Work Order ID 83061

Item Name: Crosstube Fwd

DART AEROSPACE LTD		Work Order:	83061
Description: Crosstube High Fwd (205/212/412)		Part Number:	D212-664-101
Inspection Dwg: D212-664-141 Rev: D		Page 1 of 1

DRAWING NO. D212-664-141	TITLE XTUBE ASSY (205/212/412 HI FWD)	REV. D	DART AEROSPACE LTD ENGINEERING ORDER		D.E.O. NO. D212-664-141-D-1	SHEET NO. SHEET 1 OF 2	SCALE NTS
DRAWN	CHECKED <i>IP</i>	MFG. APPR. <i>ER</i>	APPROVED <i>MP</i>	DE APPR. <i>MP</i>			
DATE 11.04.07	DATE 11.07.11	DATE 11.04.12	DATE 11/04/12	DATE 11.04.12

**D212-664-141/-141B
ASSEMBLY DETAIL**

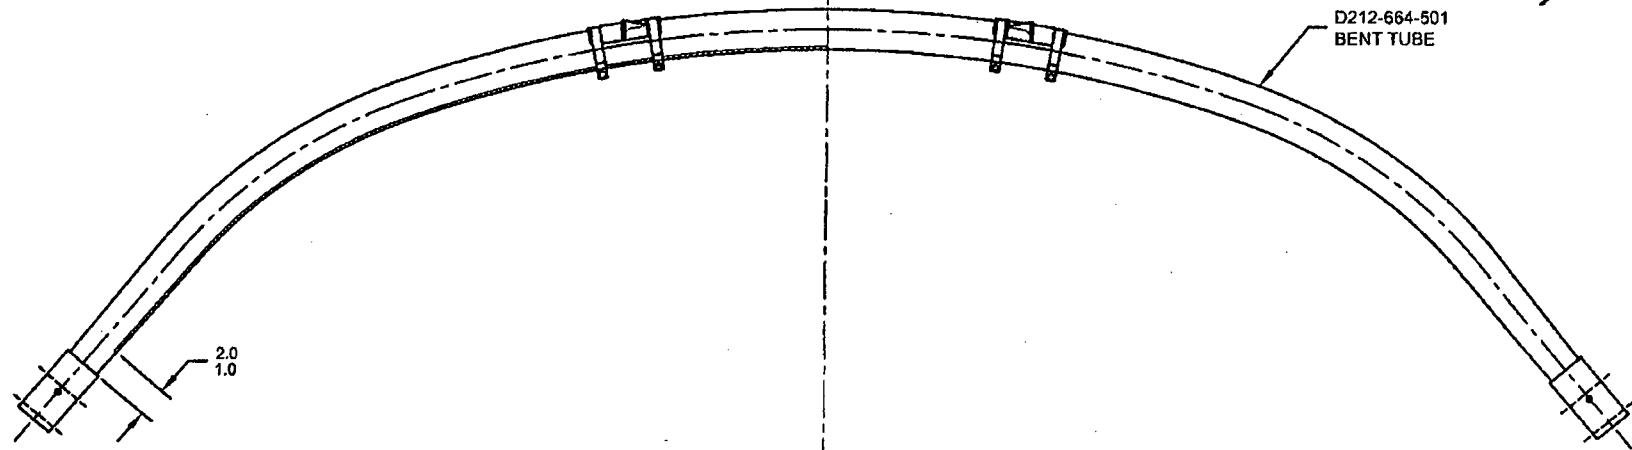
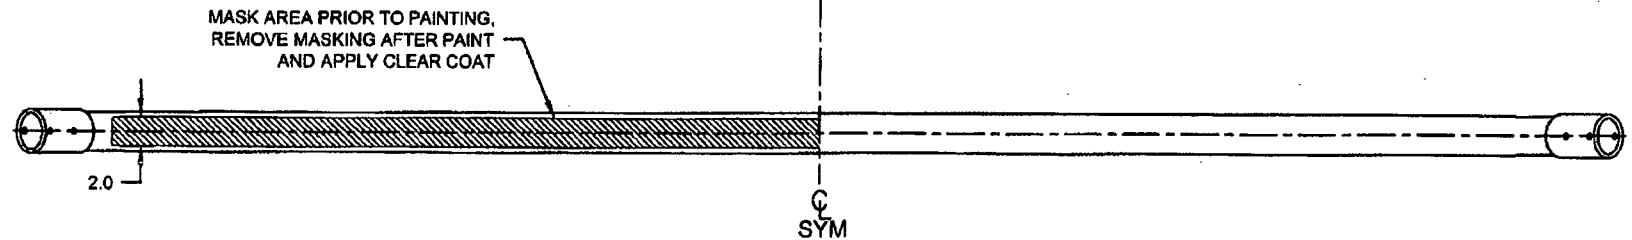
ADD AN INSPECTION WINDOW TO UNDERSIDE OF CROSSTUBE.

NOTES 2 OF SHEET 1 IS AMENDED AS FOLLOWS:

- 2) FINISH: CHEMICAL CONVERSION COAT PER DART QSI 005 4.1
PRIME INSIDE AND OUTSIDE PER DART QSI 005 4.2
MASK UNDERSIDE OF CROSSTUBE AS SHOWN (HATCHED AREA) AND
PAINT OUTSIDE PER DART QSI 005 4.2
REMOVE MASKING AND APPLY CLEAR COAT
